ADDENDUM

April 3, 2020

ADDENDUM # 3 Bid 20C6, Waverley Elementary School - New Construction

PRE-KINDERGARTEN PLAY STRUCTURE (1)

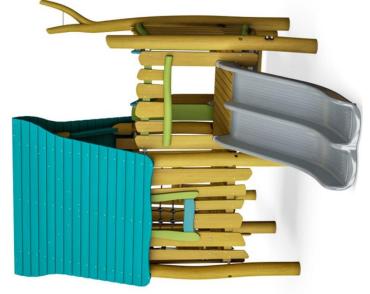
1. The drawings don't indicate where and what type of playground equipment is being installed. Could you please clarify where and what type of equipment is desired?

3. Please reference 116813- Playground Equipment, the specification states to provide Robinia Series, "Parkour" structures by Kompan but Kompan is not listed as an acceptable manufacturer under 2.1 paragraph of the specification. Please confirm Kompan is an acceptable manufacturer. Please also indicate on the drawings where this piece is to be installed.

Addendum #3 will include an augmented architectural site plan with equipment configurations for design intent only. The approved distributors/manufacturers listed in the specifications are to submit configurations derived from the Robina series by Kompan. Addendum #3 will also contain a typical detail for playground safety surfacing; the GameTime standard detail is attached to this response. The specification does not state to provide Robina series by Kompan. It states that structures and configurations should "resemble" these items as they are for design intent only.

I:\Proi\1701110 - Waverley ES\Drawings 1701110\DWG\IP-C-1B PHASE 1 DEMOLITION PLAN.dv

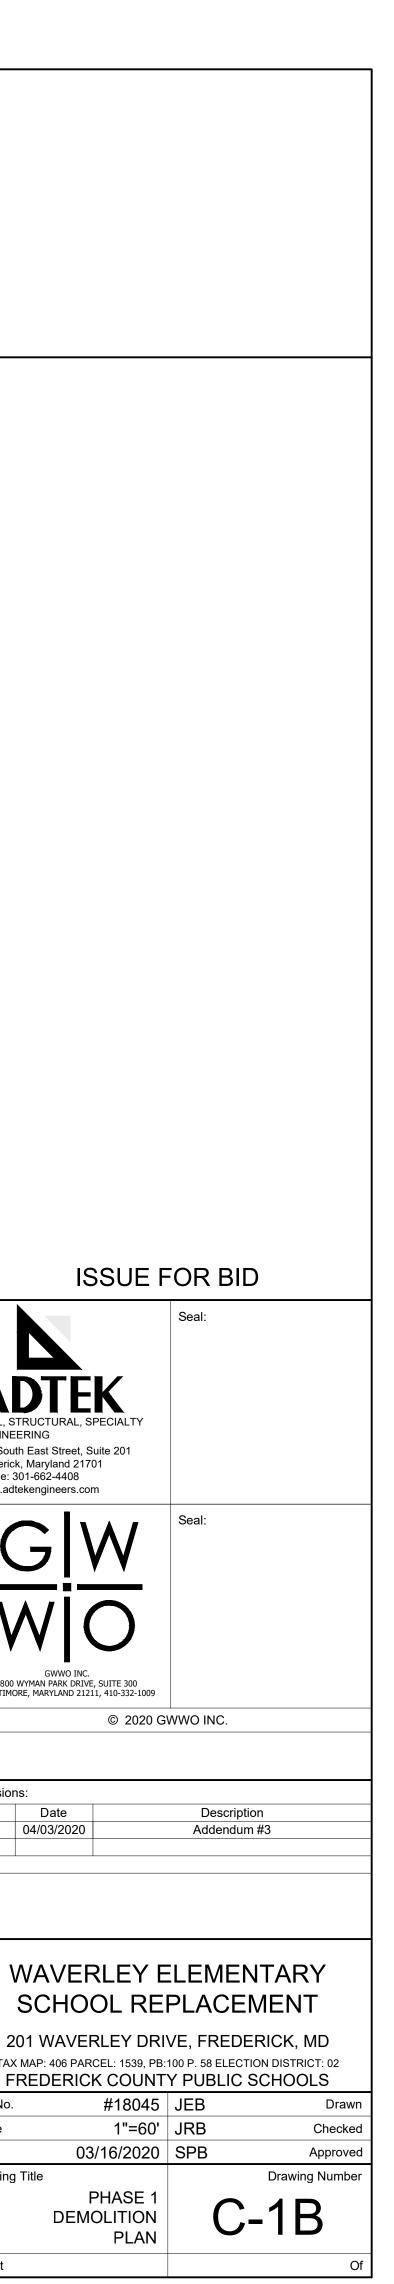
- DELETE Drawing Sheet C-1B PHASE 1 DEMOLITION PLAN; Issued for Bid, dated 03/06/2020; ADD Drawing Sheet C-1B – PHASE 1 DEMOLITION PLAN; ADDENDUM #3, (Revision dated 04/03/2020).

- **REVISED** scope of demolition work to include on-site walking path adjacent to the existing Waverley facility.
 - DELETE Drawing Sheet C-1D PHASE 3 DEMOLITION PLAN; Issued for Bid, dated 03/06/2020; ADD Drawing Sheet C-1D – PHASE 3 DEMOLITION PLAN; ADDENDUM #3, (Revision dated 04/03/2020).

I:\Proi\1701110 - Waverlev ES\Drawings 1701110\DWG\IP-C-1D PHASE 3 DEMOLITION PLAN.dwc

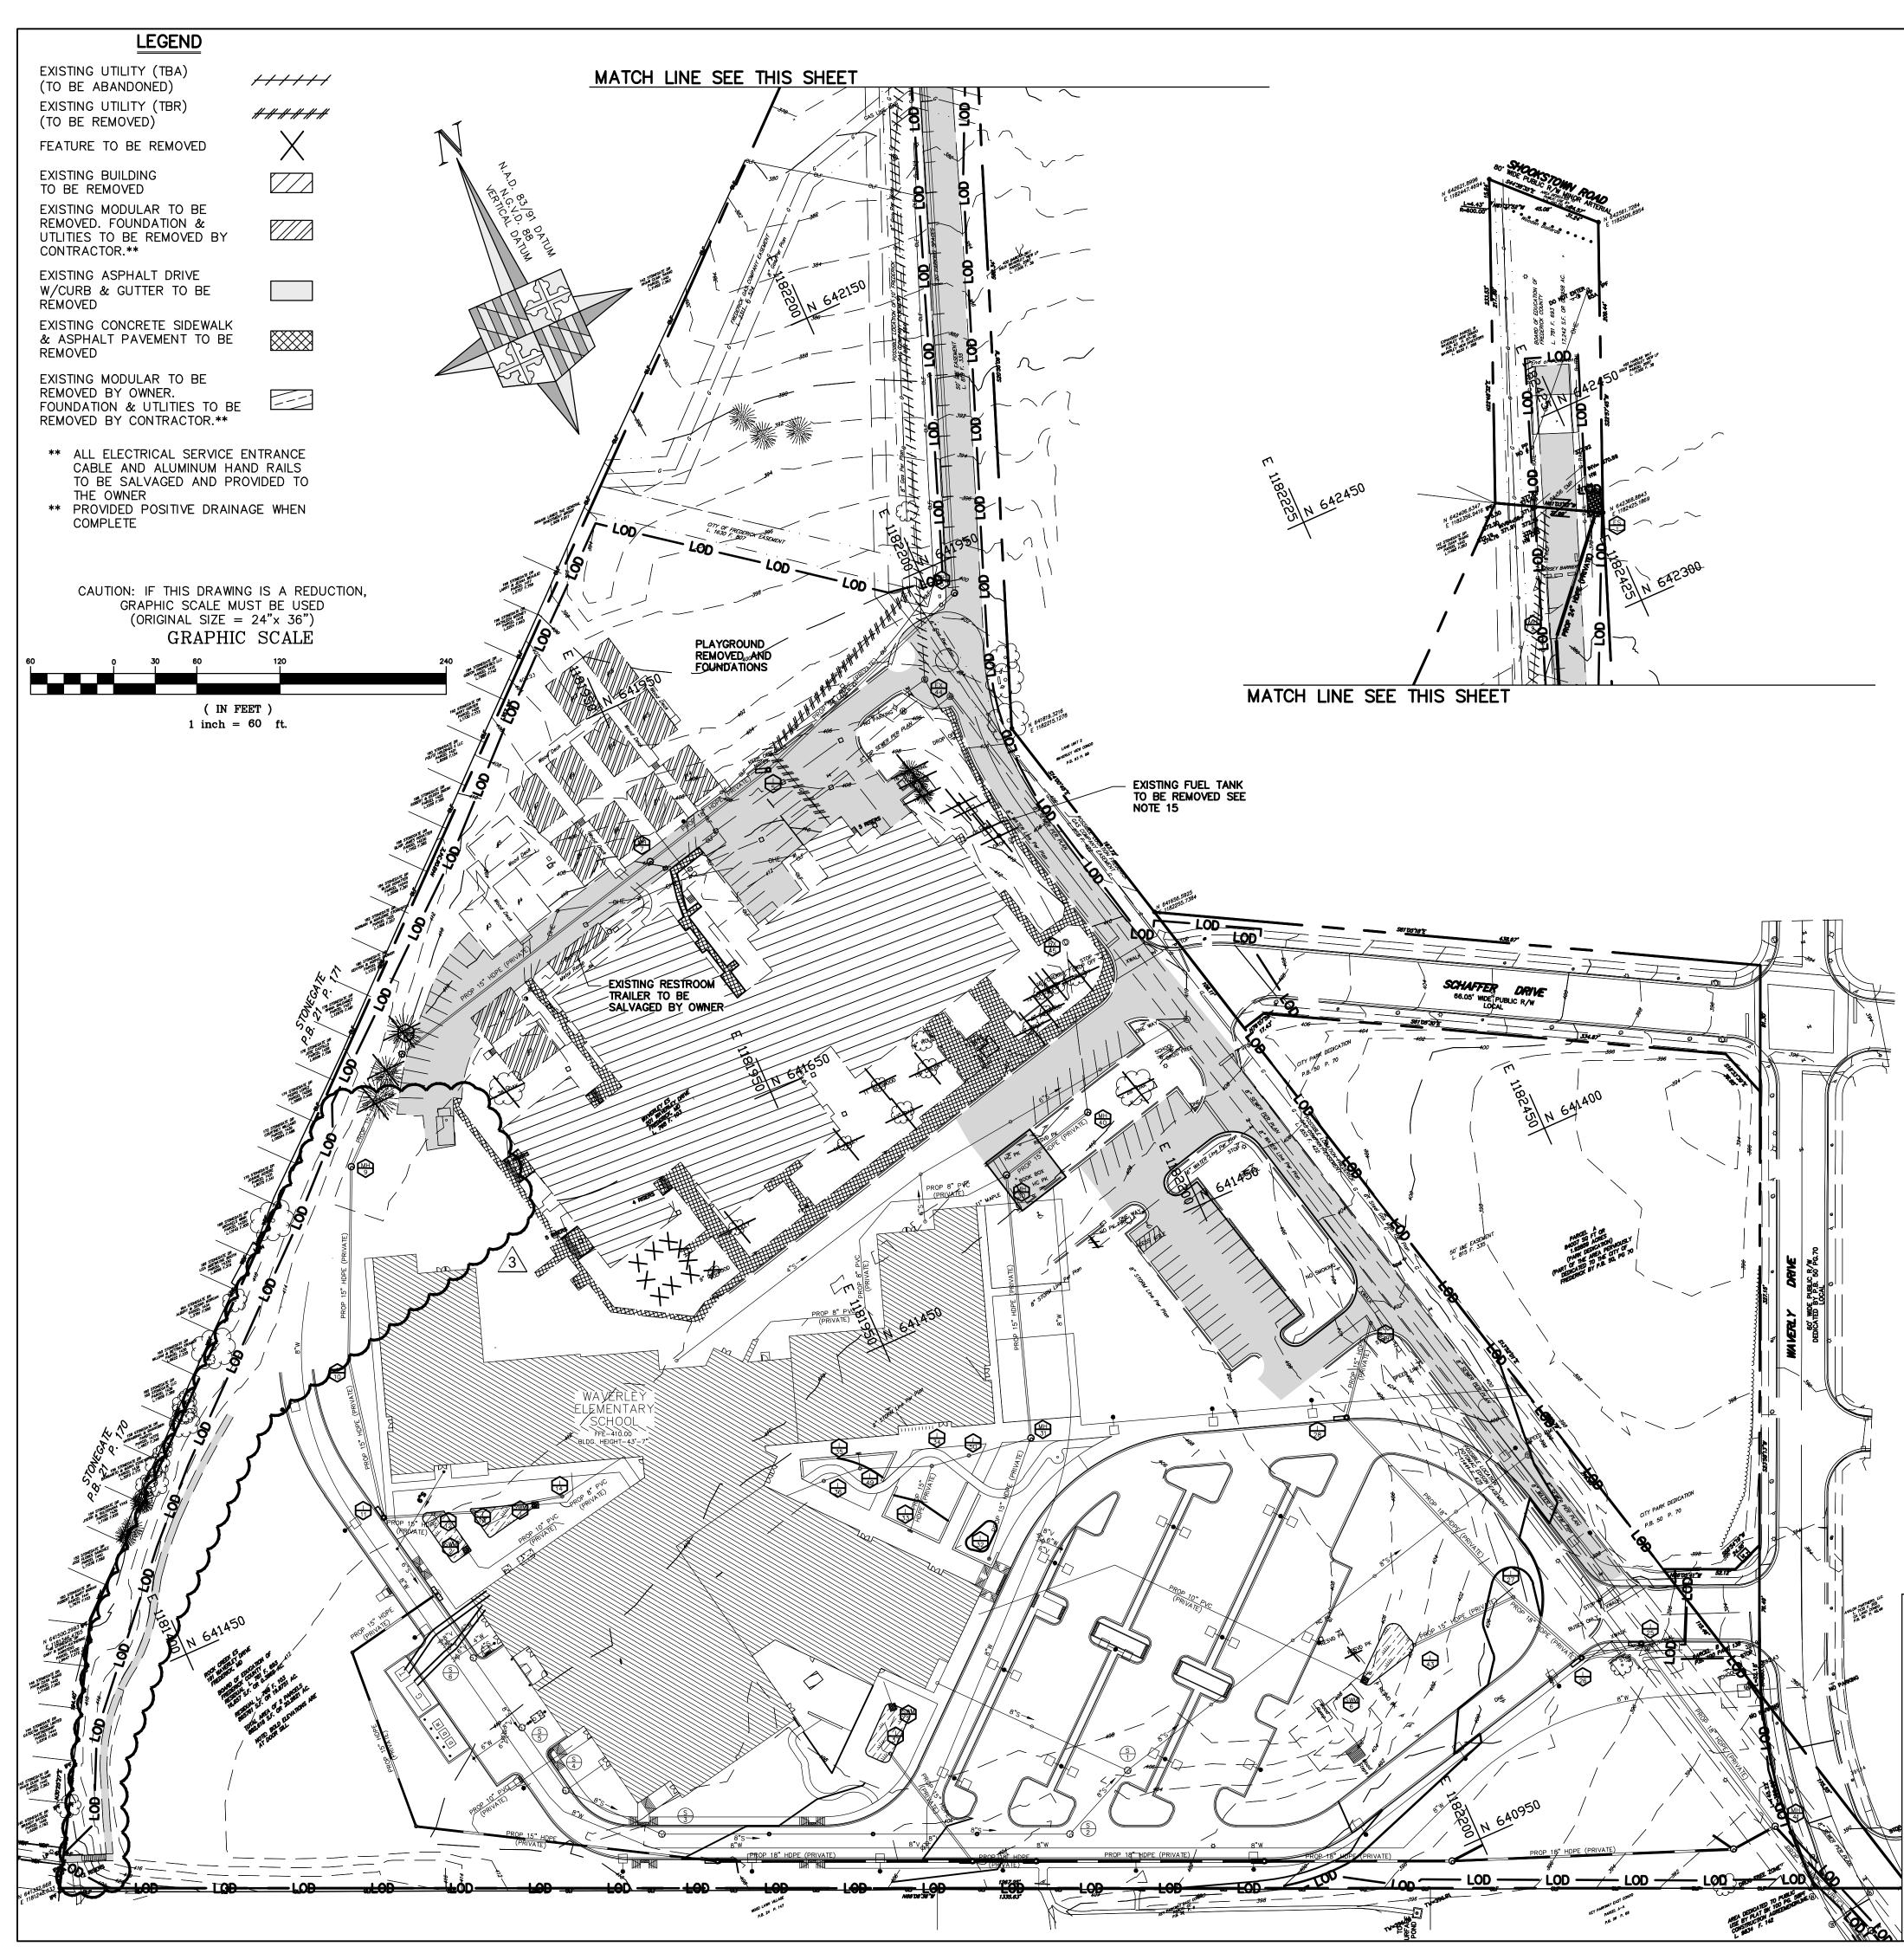
- **REVISED** scope of demolition work to include steps and subsequent on-site path from Stonegate.
 - 4. **REVISE** Drawing Sheet C-2B PHASE 1 SEDIMENT CONTROL PLAN; Issued for Bid, dated 03/06/2020.

roi\1701110 - Waverlev ES\Drawings 1701110\D\VG\IP-C-4H STORMDRAIN PROFILES.dw

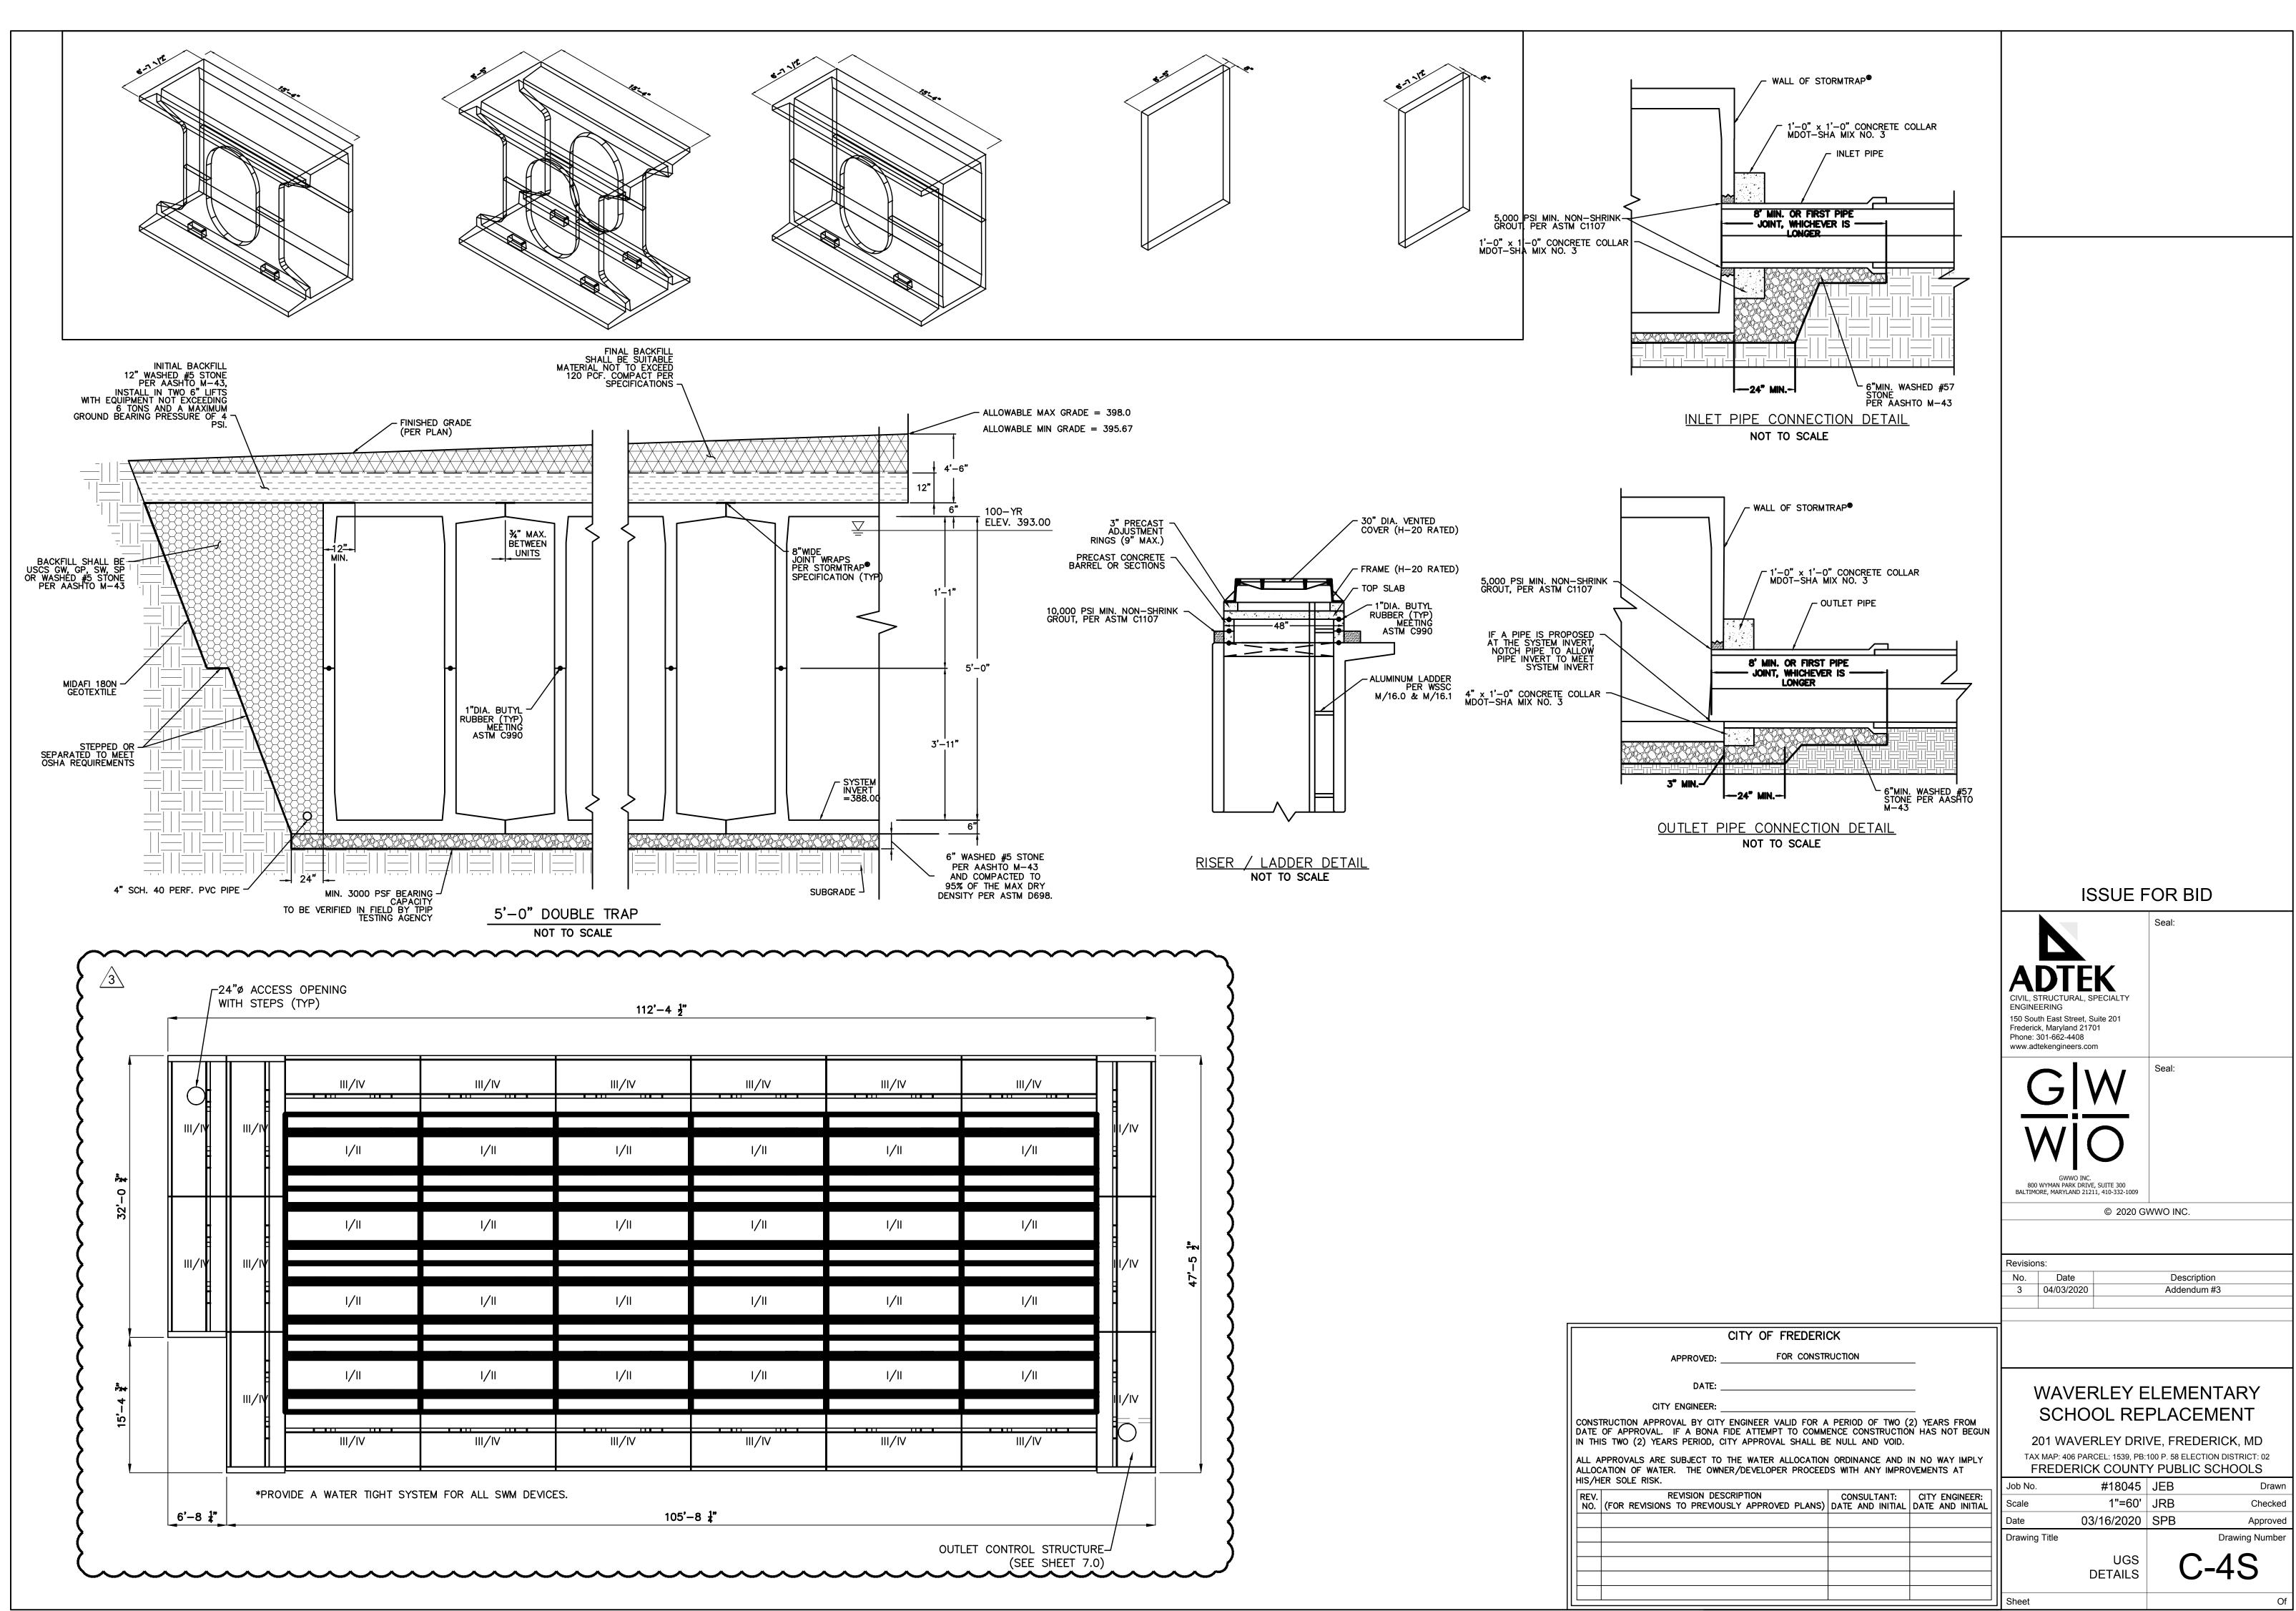
- ADDED Detail 10 of typical poured-in-place playground surfacing.
- DELETE Drawing Sheet C-4H STORMDRAIN PROFILES; Issued for Bid, dated 03/06/2020; ADD Drawing Sheet C-4H – STORMDRAIN PROFILES; ADDENDUM #3, (Revision dated 04/03/2020).

- REVISED profiles to and from UGS-1.
 - **REVISED** Storm Trap notes.
- 10. **DELETE** Drawing Sheet C-4S UGS DETAILS; Issued for Bid, dated 03/06/2020; **ADD** Drawing Sheet C-4S UGS DETAILS; ADDENDUM #3, (Revision dated 04/03/2020).
